Product Change Notification

111852 - 00

Change Notification #: 111852 - 00
Change Title: Intel® Server Board S2600CO Product Family
PCN 111852-00, Product Design Update BIOS/BMC/FRUSDR Firmware and Change the Capacitor on the Board at Location C4A9
Date of Publication: November 28, 2012

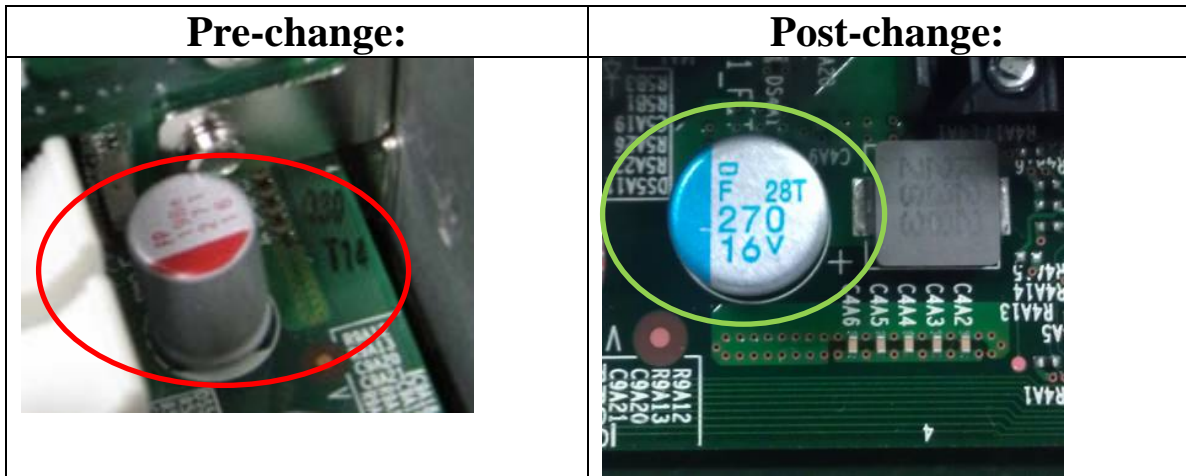
4. Change the capacitor on the board at location C4A9 to lower the capacitor height. The following are pictures of the Pre and Post change of the capacitor:
